FINAL
ENVIRONMENTAL STATEMENT

CALLEGUAS CREEK
SIMI VALLEY TO MOORPARK
VENTURA COUNTY, CALIFORNIA

Prepared by
Office of the Chief of Engineers
Department of the Army
Washington, D.C. 20314

June 1976

PLATE 4
PRIME AGRICULTURAL LAND

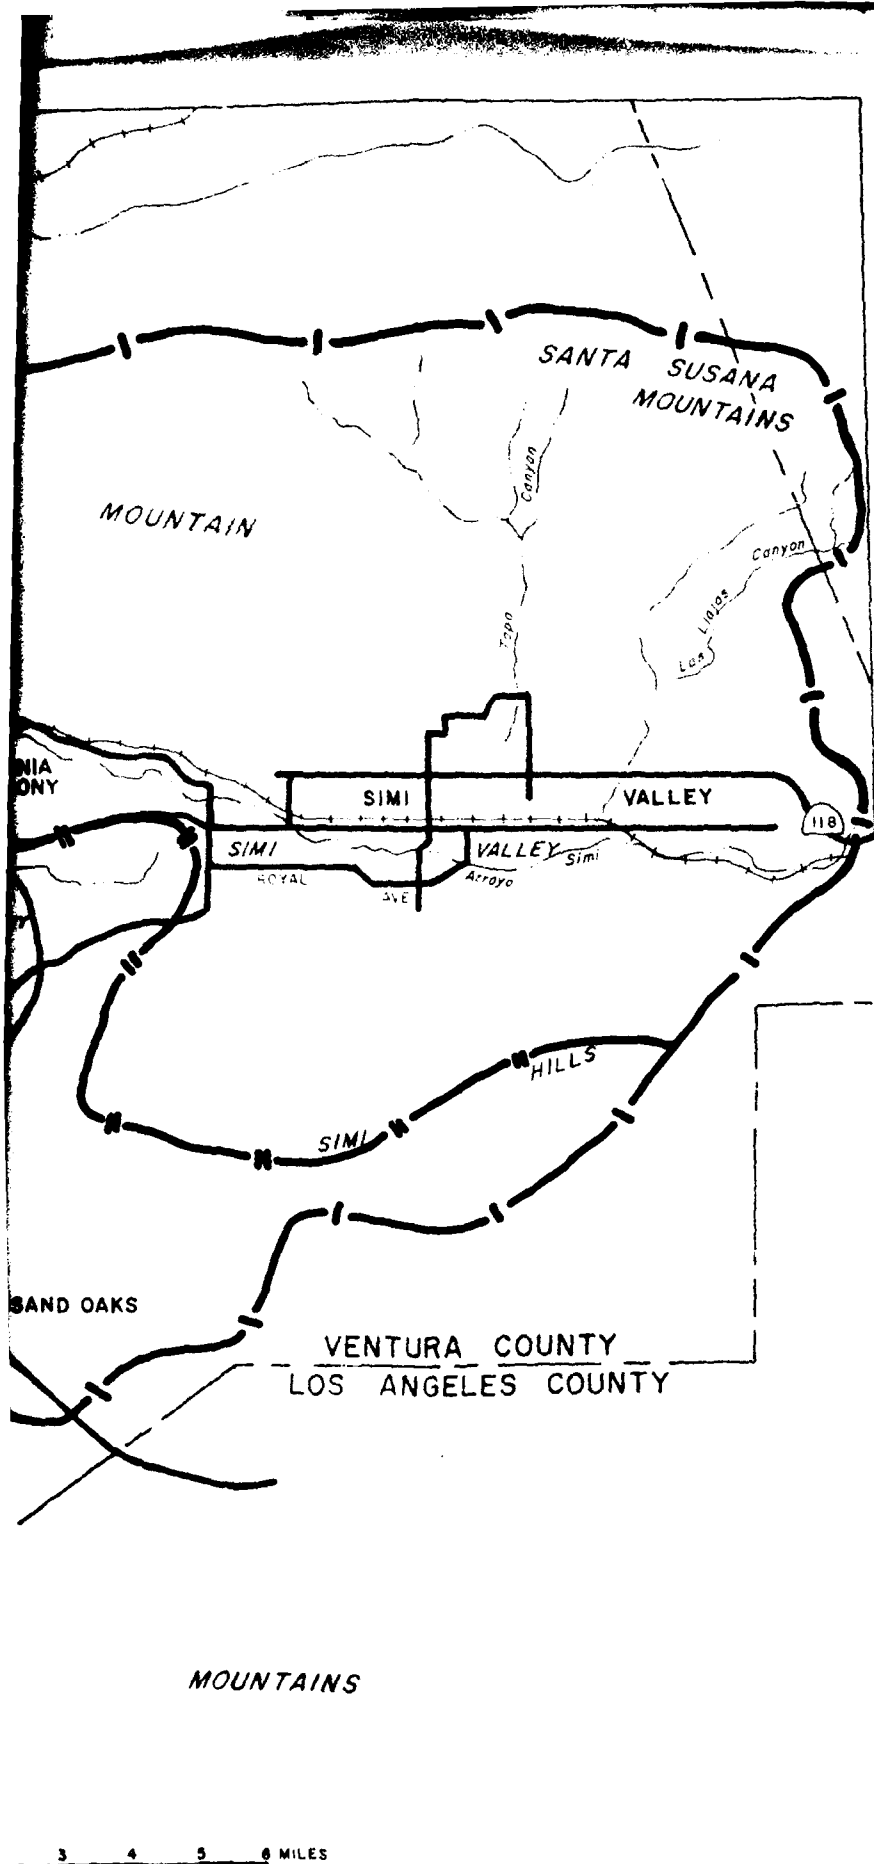
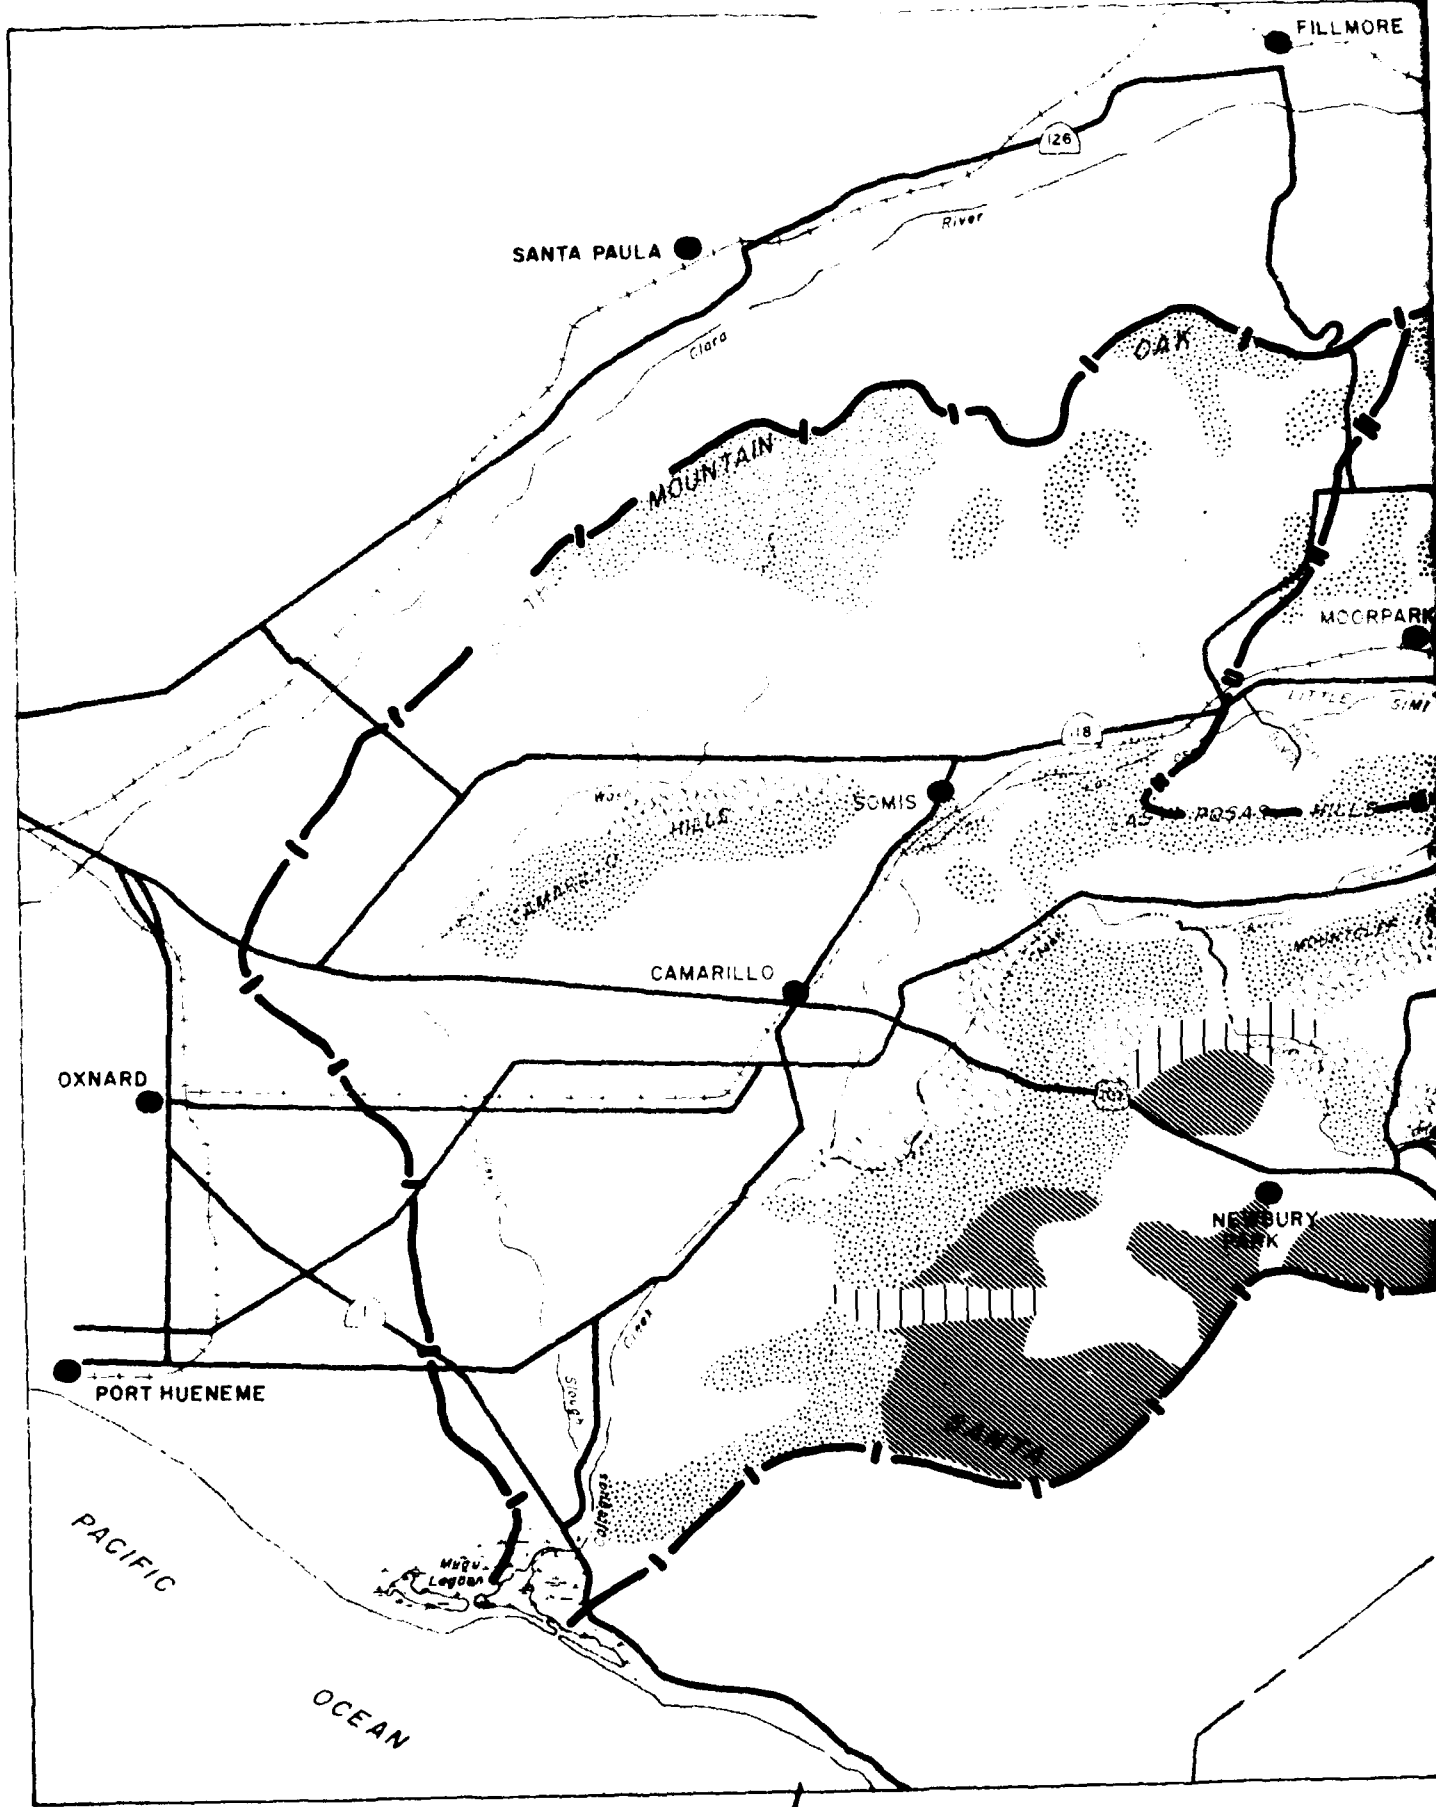
Comment: Plate 4 identifies prime agricultural land within Ventura County. For clarification purposes, the area shown on this plate is the Agricultural Element of the Ventura County General Plan as adopted by the Board of Supervisors.

11. Plate 4 identifies prime agricultural land within Ventura County. For clarification purposes, the area shown on this Plate is the Agricultural Element of the Ventura County General Plan as adopted by the Board of Supervisors.

PLATE 5
NATURAL COMMUNITY
DISTRIBUTION

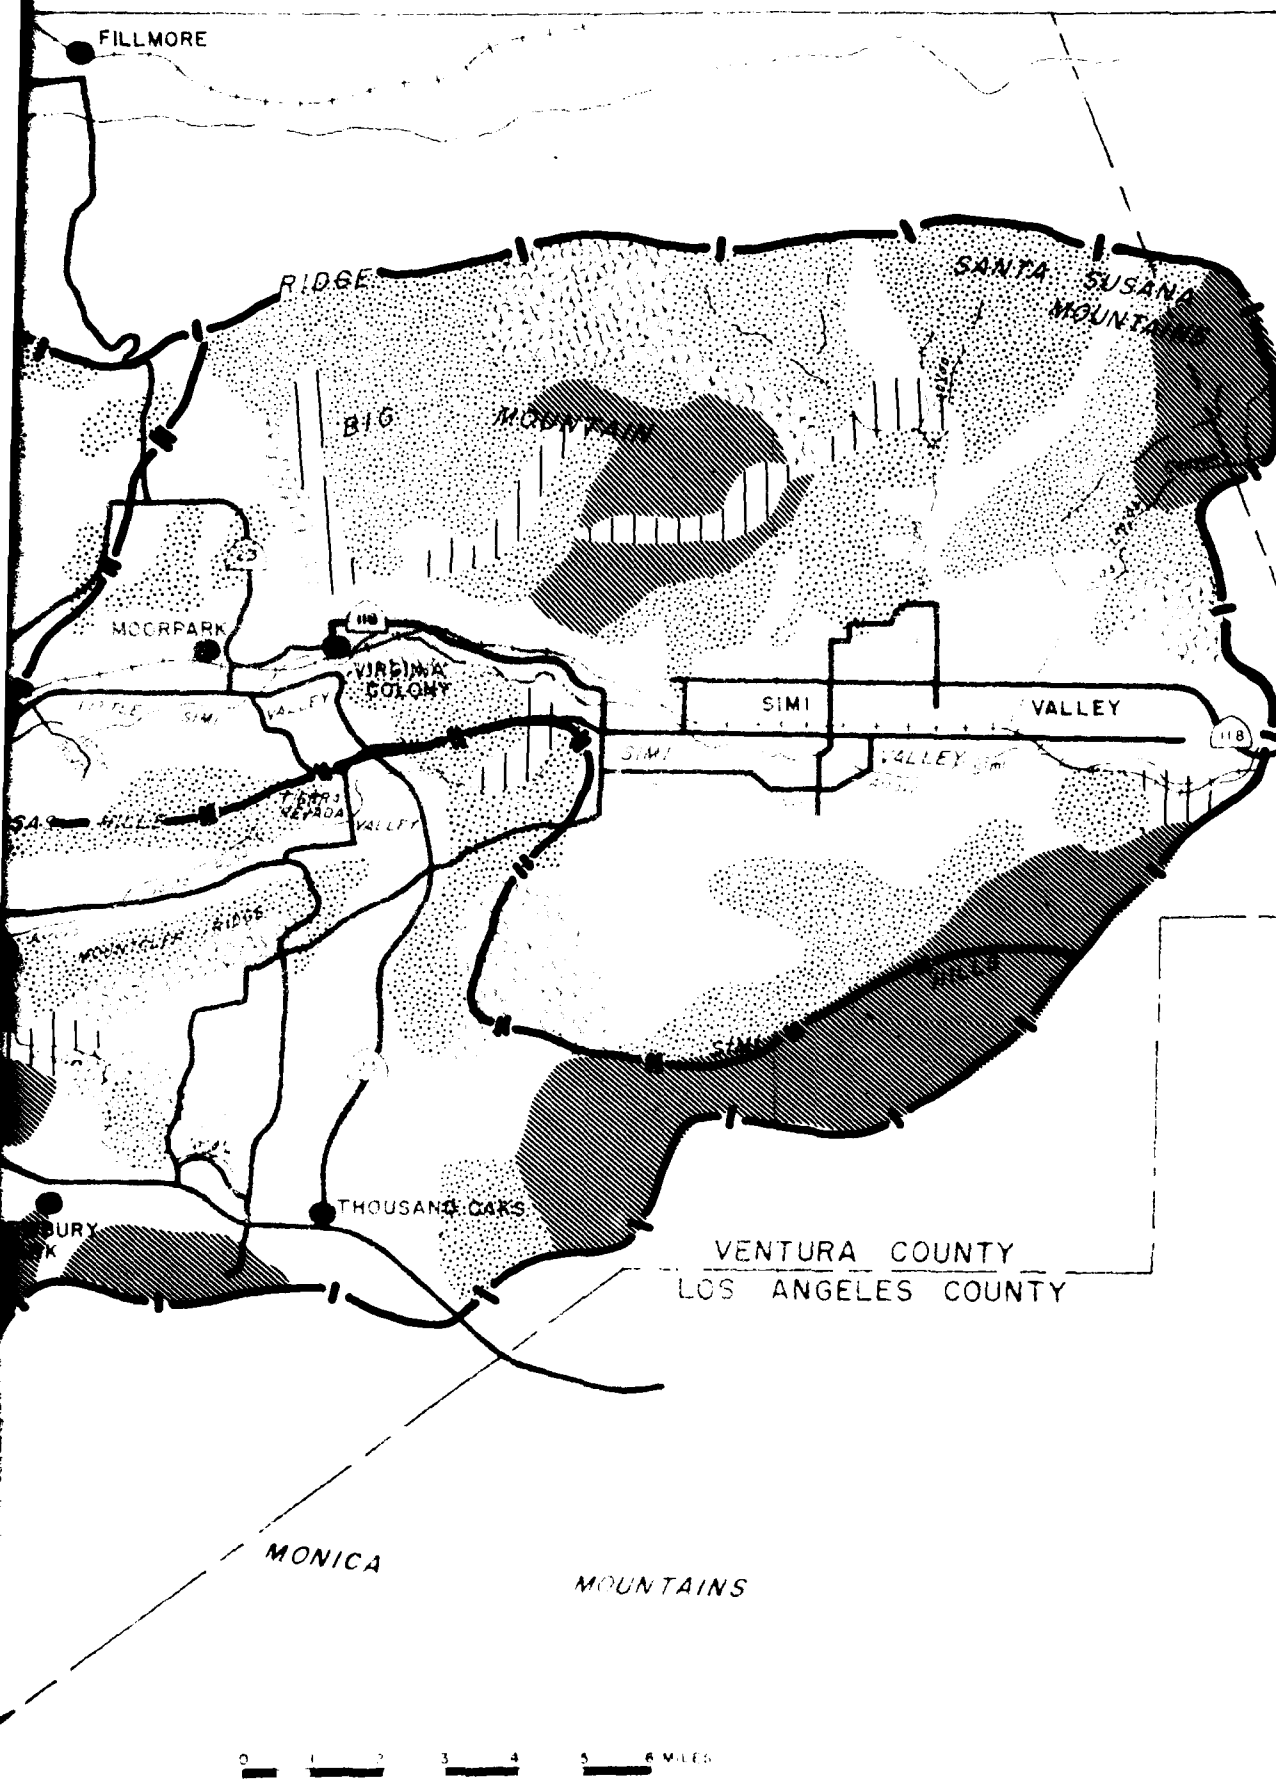
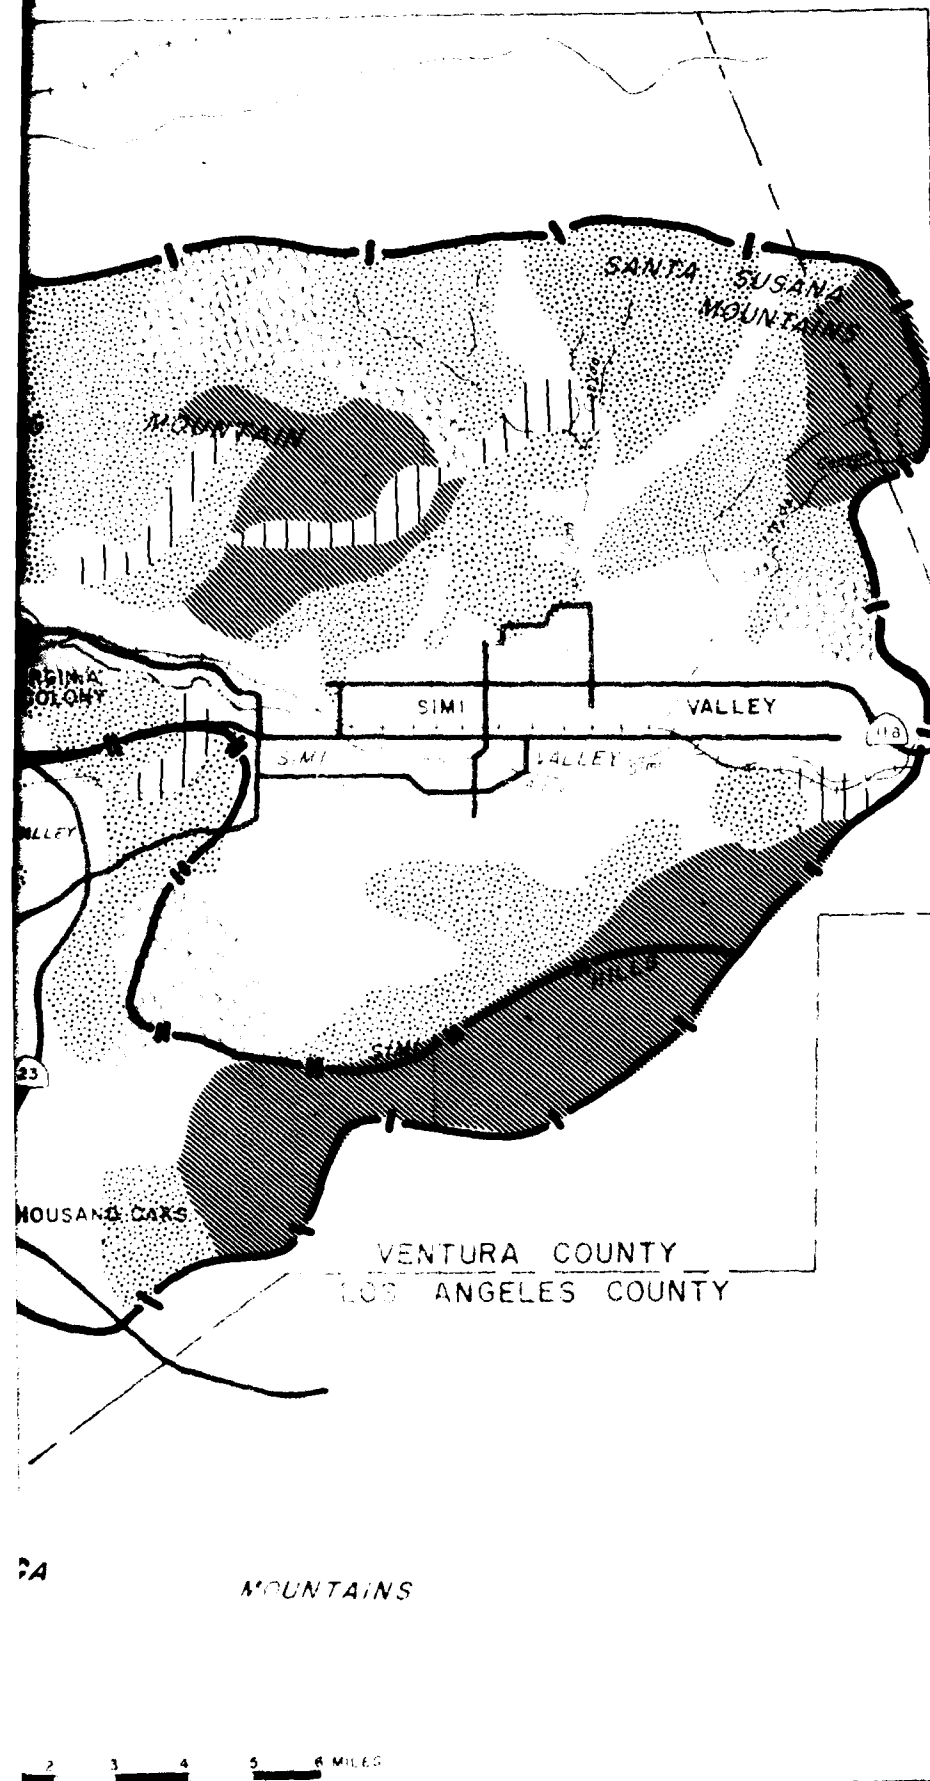
Comment: The statement should take cognizance of the project's impact on biological communities in the reach between Simi Valley and Moorpark. Perhaps more recent photographs should be included in the statement to indicate the lush vegetation that has developed in the area and this condition reflected in plates 5, 6, and 7.

Response: The only impact on the biological communities between Simi Valley and Moorpark would result from recreation trails and use of these trails. The environmental statement has been modified to reflect the impact of recreation on the biological communities. The photos were taken in the spring of 1973. Presence of bush riparian growth is dependent on the amount of waterflows in the streambed. Larger flows remove growth. Plates 5, 6, and 7 do reflect the riparian community in relation to the map topics.
